SKYLINE COLLEGE

STUDENT SUPPORT & COMMUNITY SERVICES CENTER AND SCIENCE ANNEX BUILDING

DSA INCREMENT ONE SUBMITTAL

OCTOBER 21, 2004 PROJECT RECORD DOCUMENTS

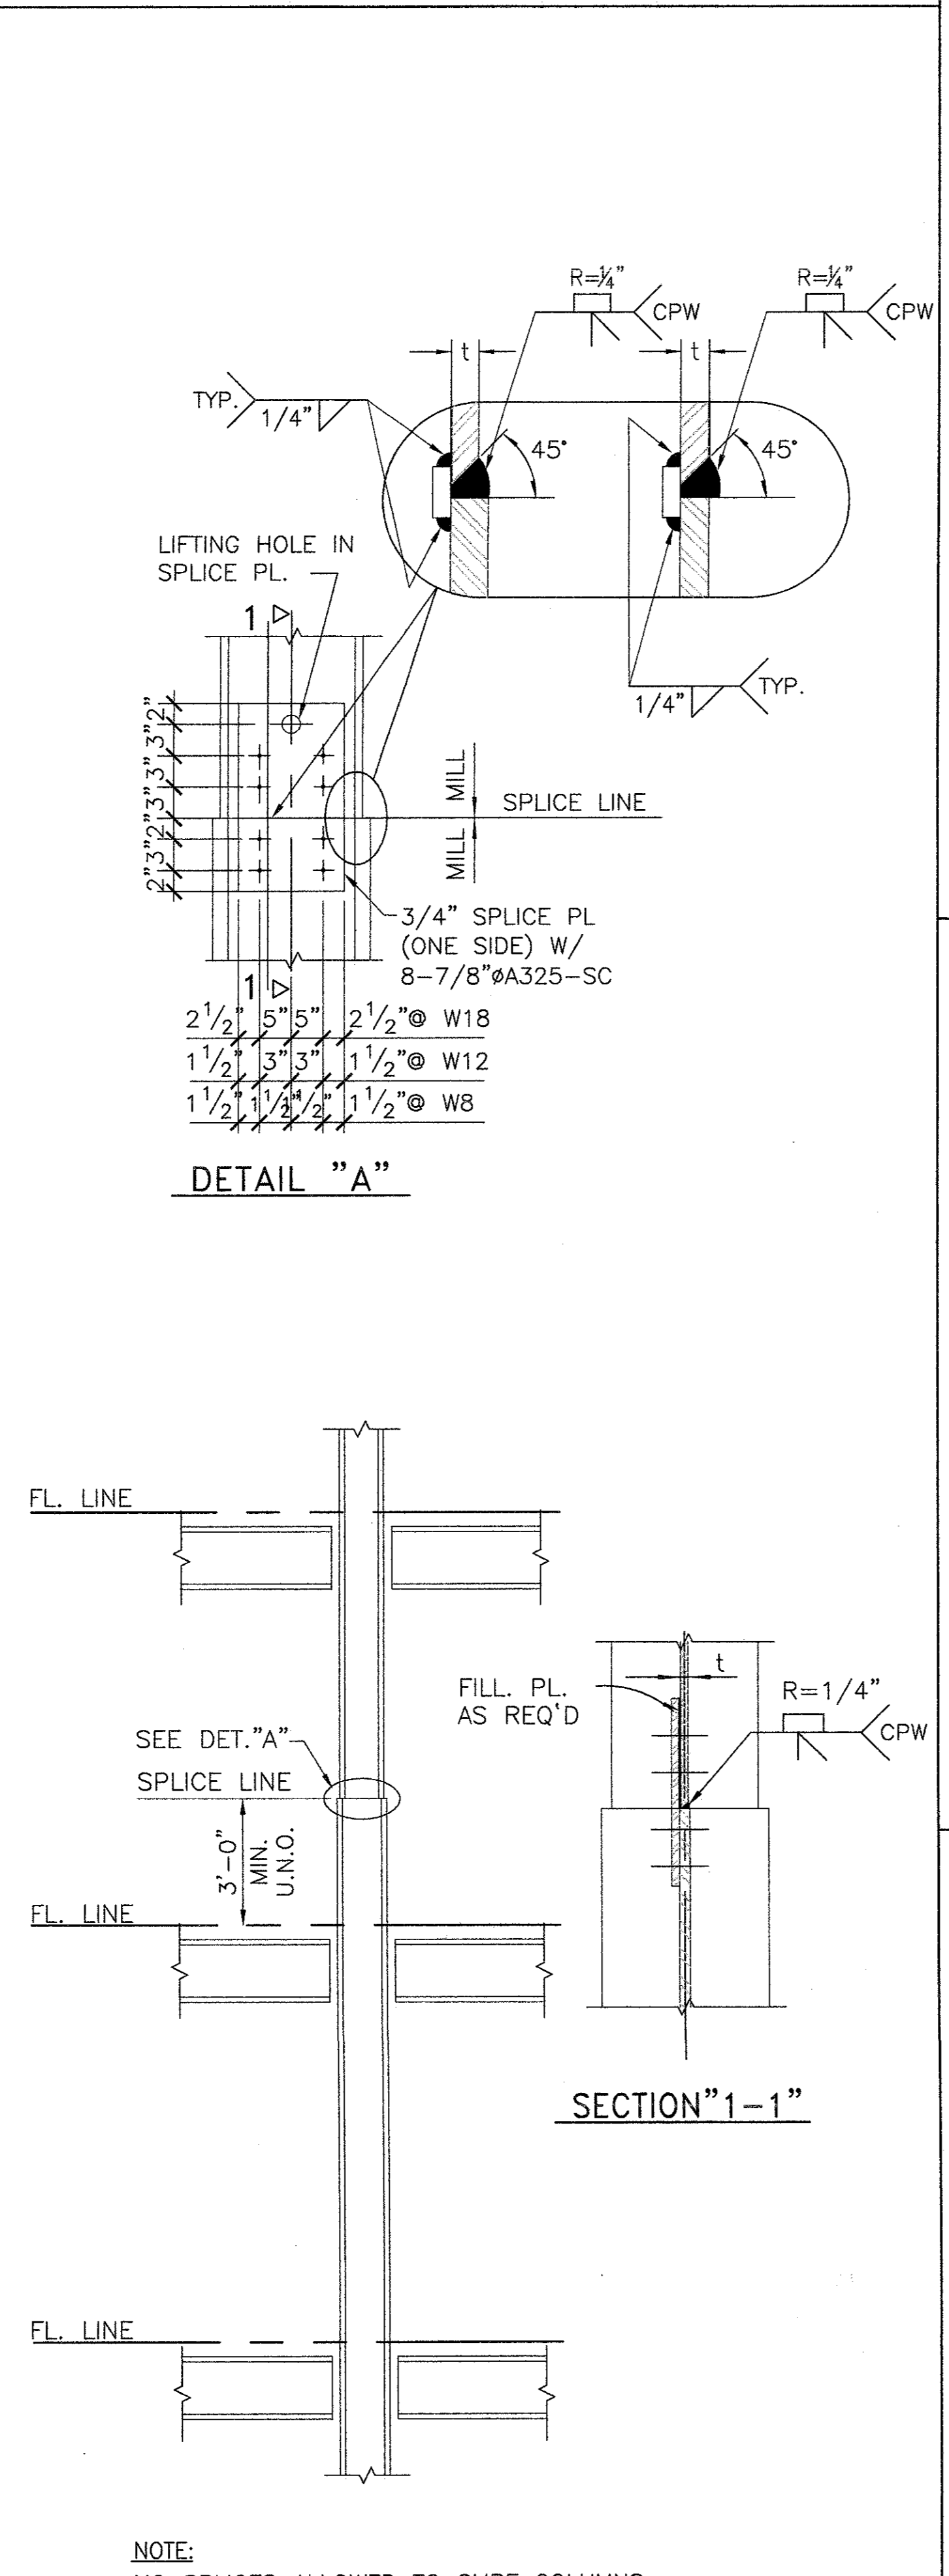
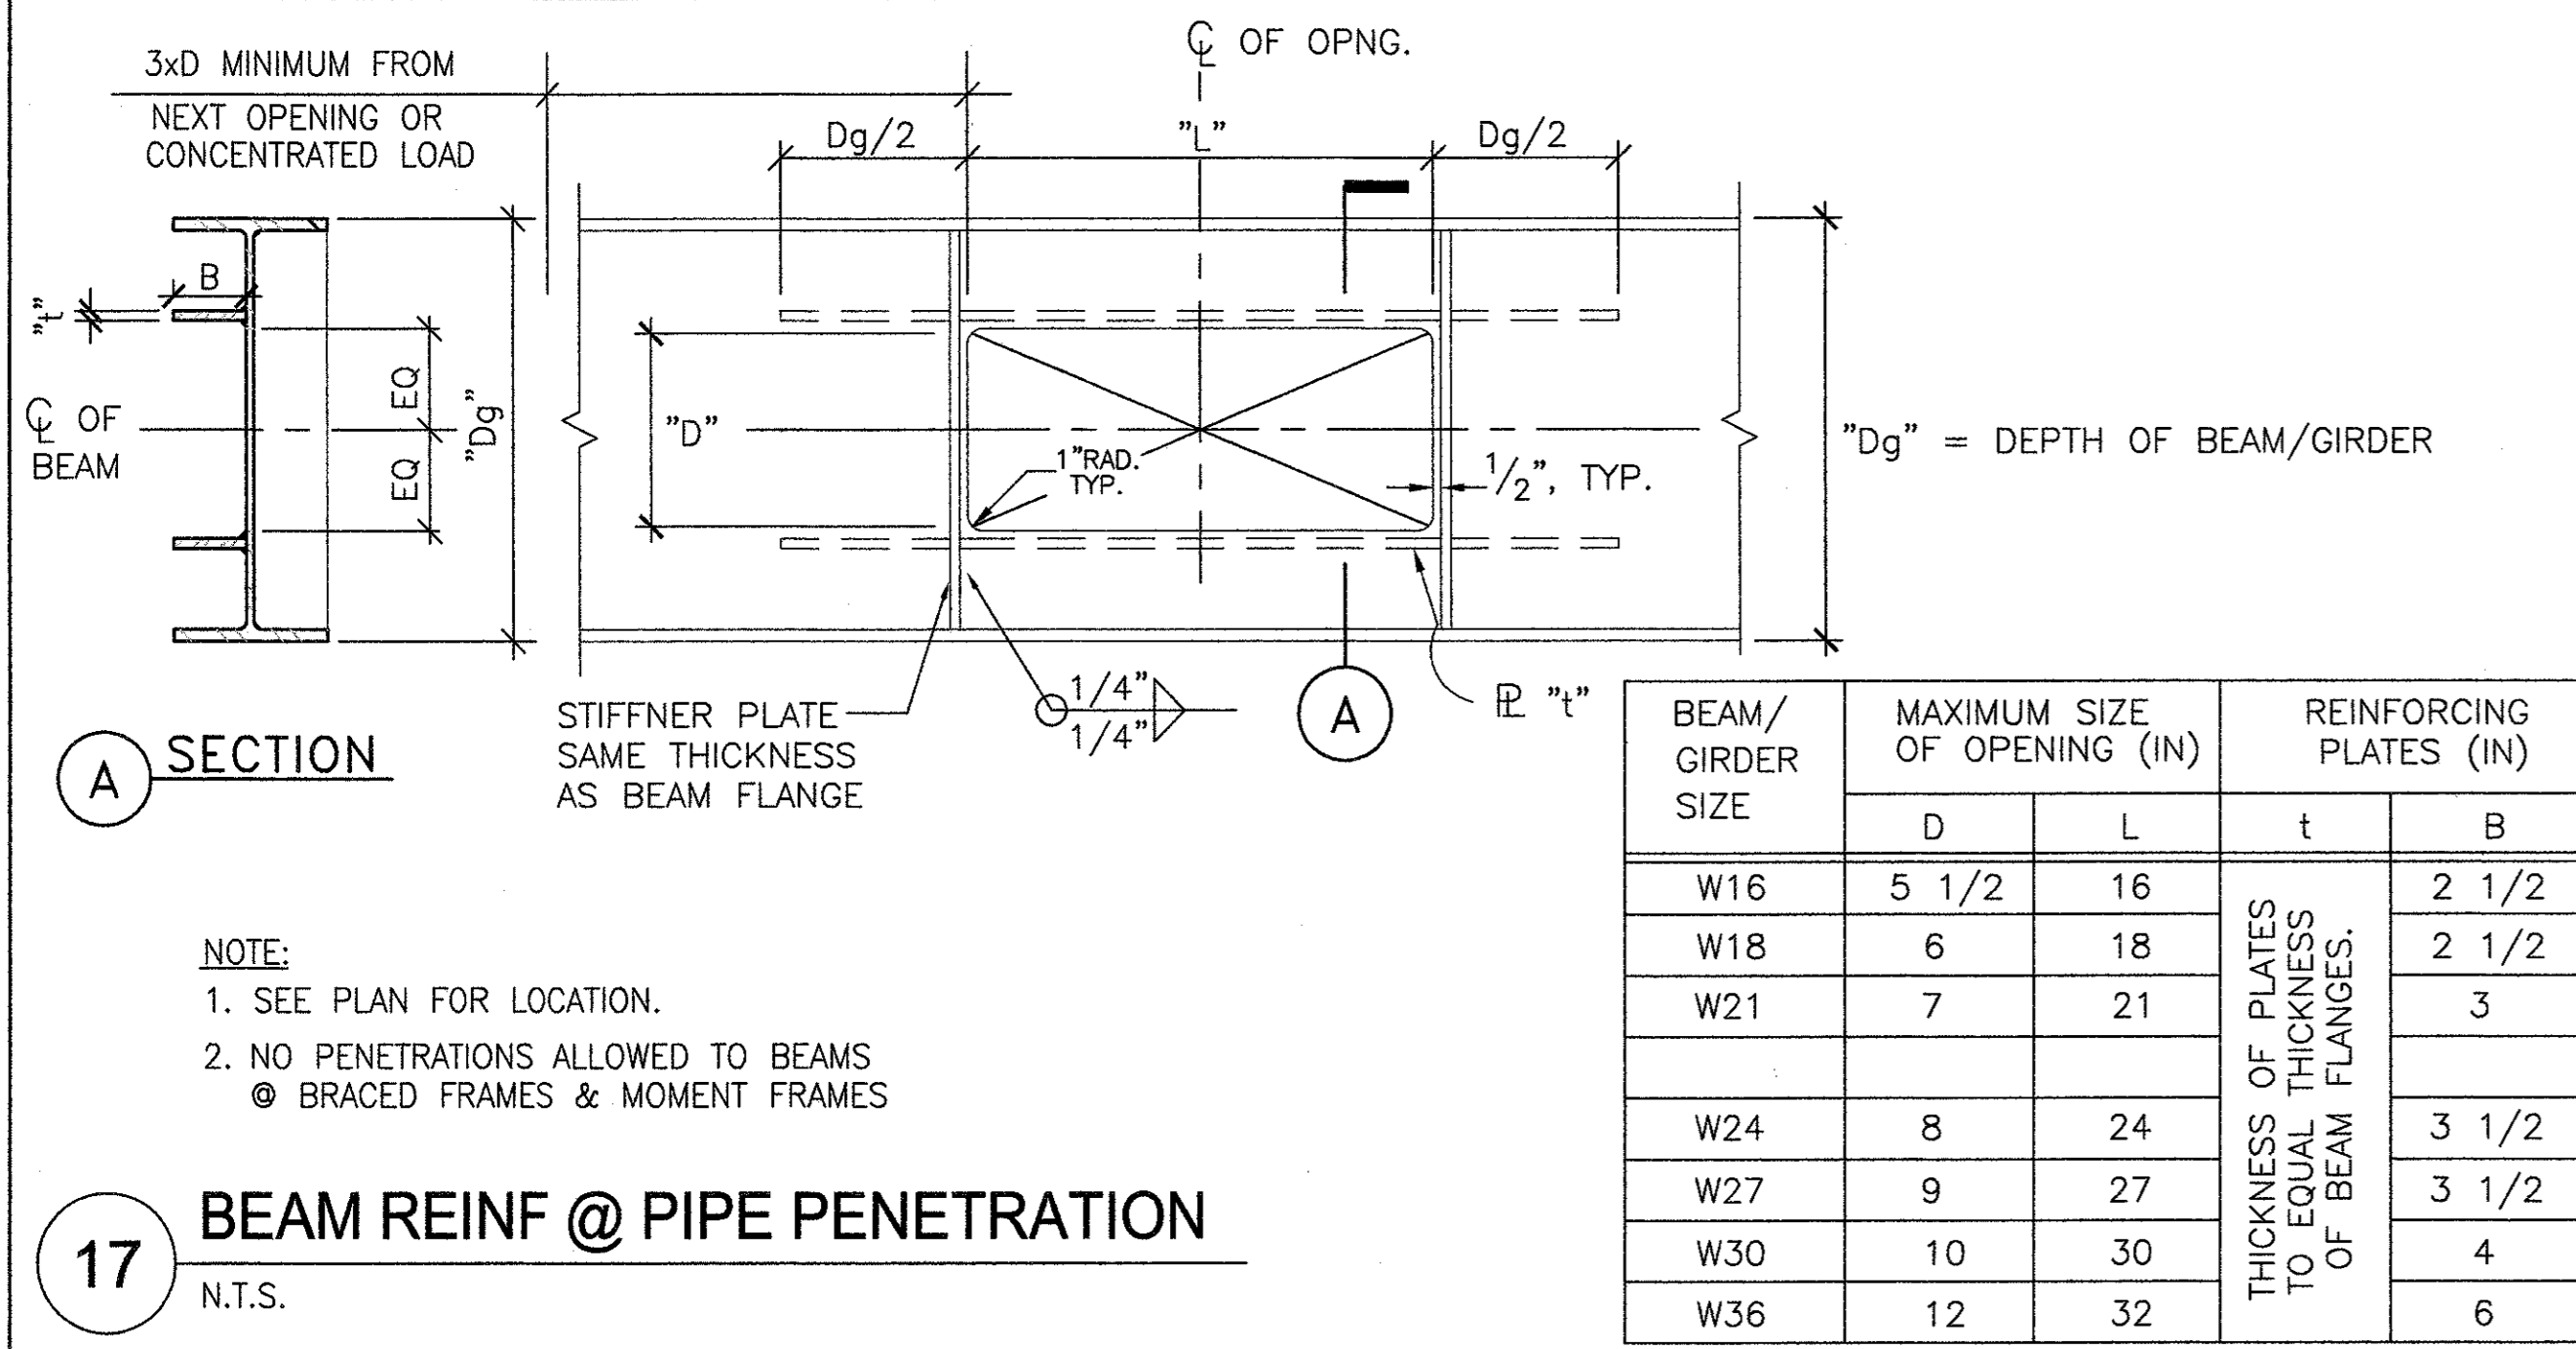
Question
Please verify that detail 10 on sheet S1.6 of Increment One drawings is to occur on only one side of the beam. If not please provide locations.

Question:
Detail 1 of sheet S1.5 of Moment Connection at Gravity Columns refers to detail 2 of sheet S1.6 for the type of bolts to be used in the situation, calling out A325-N bolts. However, sheet S1.7 detail 1 specifies a different type of bolt, A490-SC, to be used at Moment Connections.
Please confirm moment connections at gravity columns require the A325-N bolts called out on sheet S1.6 detail 2, and not that called out on sheet S1.7 detail 1.

Question:
Reference increment No. 1, sheet S1.5, detail 1, sheet S1.6 detail 2, sheet S1.7 detail 1, and sheet S1.7 detail 1a)
For further clarification the cantilevered beams on building 6 along the perimeter at the mentioned areas are to have a moment connection per detail 1 on S1.5 and using A325 bolts.
Cantilevered beams along gridline "Q" between "1" and "3"
Cantilevered beams along gridline "6" between "1" and "12"
Beams in the "Traverse Wall" along gridline "10" between "11" all-end of 1 and 1 on 2nd and roof level.

Answer
Here is more clarification on Detail 10/S1.6:
...//...
1. At one side of all building perimeter beams
...//...
2. At one side of all openings of stairs & elevators
...//...
3. At interior locations on any one side of frame beams with not more than 10'-0" o.c. to laterally brace the top and bottom flange of frame beams. As shown on plan drawings, one lateral bracing beam will be always provided at center of brace-frame beam where braces intersect. As shown on plan drawing SB2.03 gridline 6, one lateral bracing beam will be always provided on any one side, at center of special moment frame beam and at 3'-0" away from special moment frame column-flanges.
...//...
Tejas, Crosby Group

Answer:
A490-SC bolts per det. 2 of S1.6 are required at moment connections per det. S1.6, except that if the moment connect column happens to be a collector location then det. S1.7 applies. Collector locations are marked with a dark dot on the plan or layout plans. Tejas, Crosby Group.
See comments by Tejas, Crosby Group.

Answer:
Confirmed. Tejas, Crosby Group.

SECTION @ GRADE BEAM BETWEEN LINES J & L
SCALE: N.T.S.

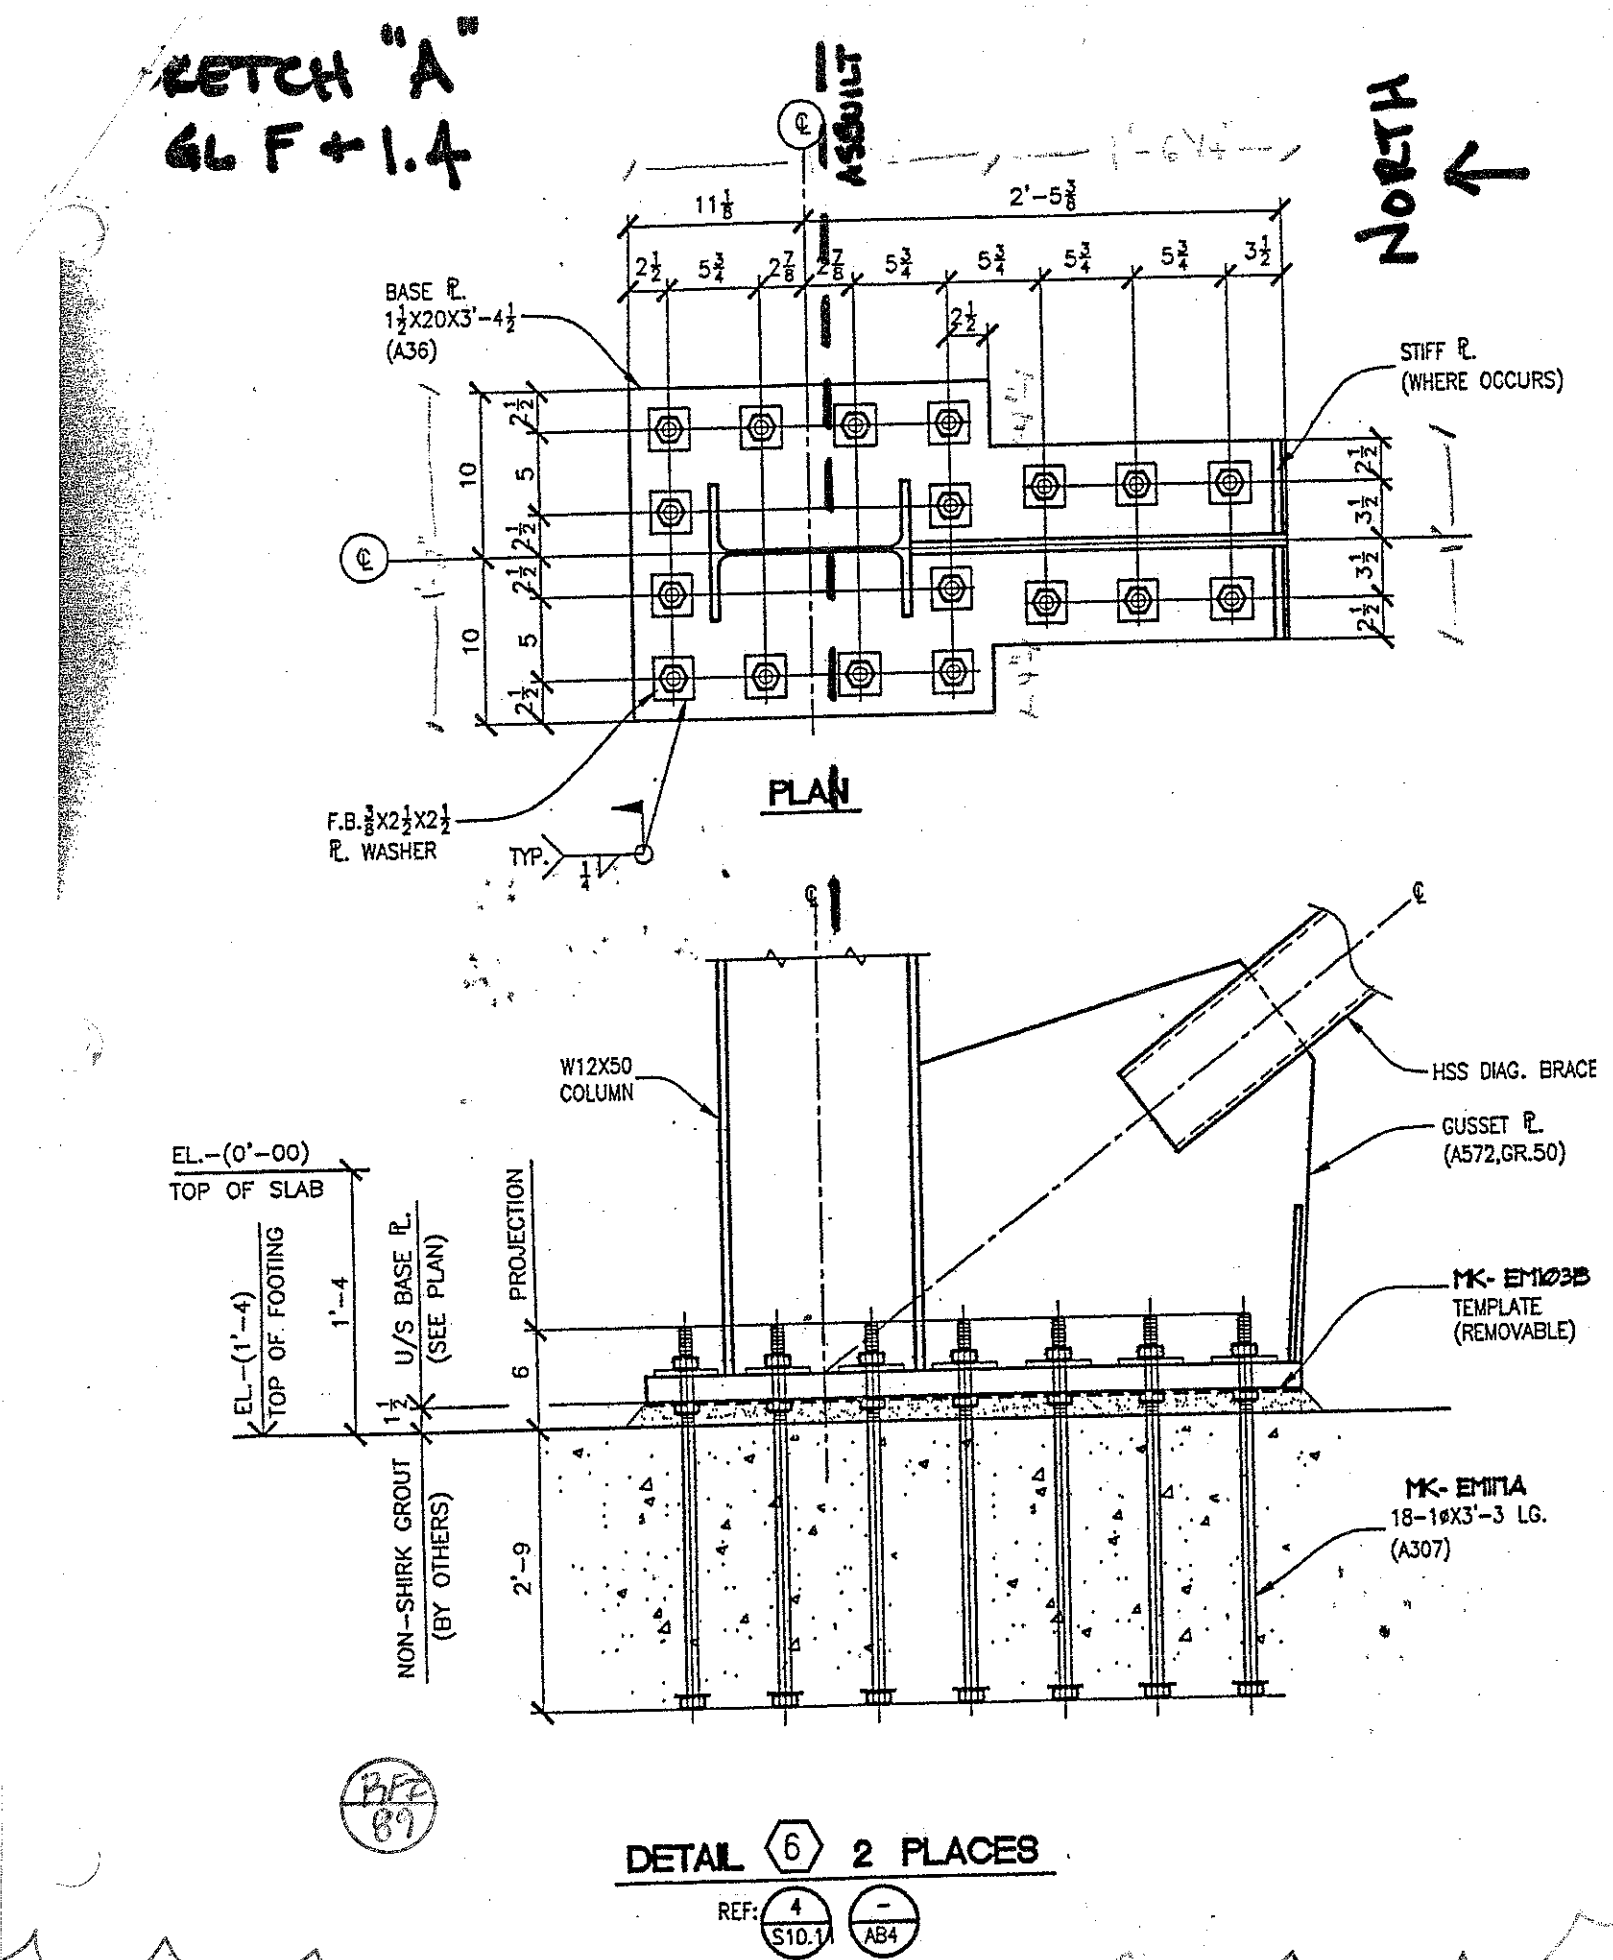
Question
Reference Sheet SB2.01 and Sketch A
